Site Plan Review

Site: 26600 Southfield Road
Applicant: BD & E Group, LLC
Plan Date: November 20, 2024
Zoning: MX Mixed Use District
Parcel ID: 24-24-104-033
Proposal: Interior / Exterior Commercial Building Renovation

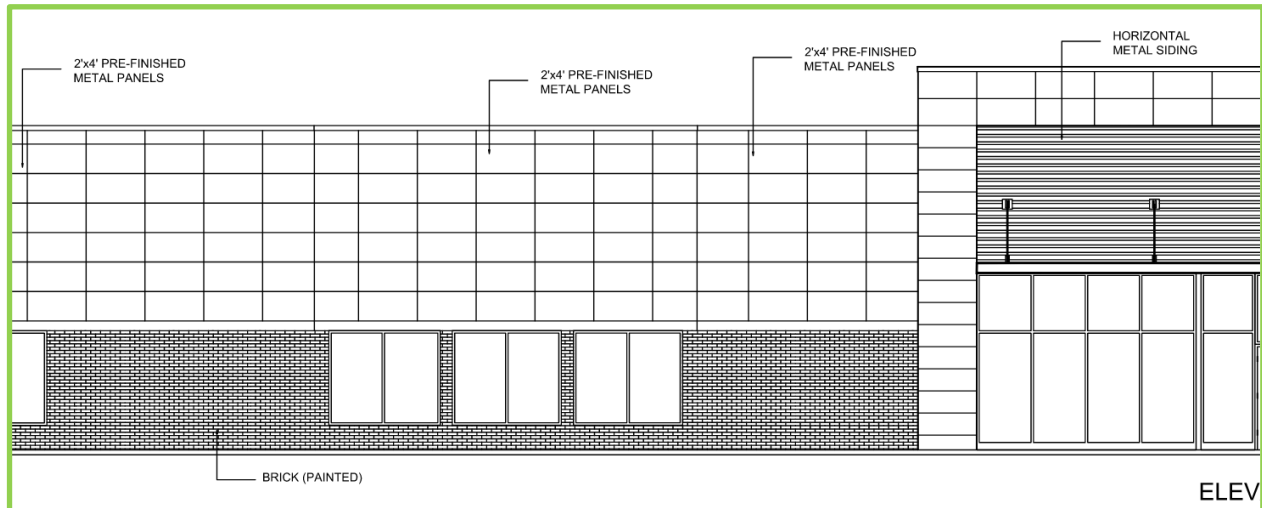
An existing wall separates the commercial site from the adjacent single-family residential property to the east, as shown in the image at right. No change is proposed to this protective barrier wall; therefore, this standard is met.

The site plan identifies an existing concrete wall, offset from the east property line by approximately 4'-2". This buffer wall is seen in the image above. This existing condition meets the ordinance standard.
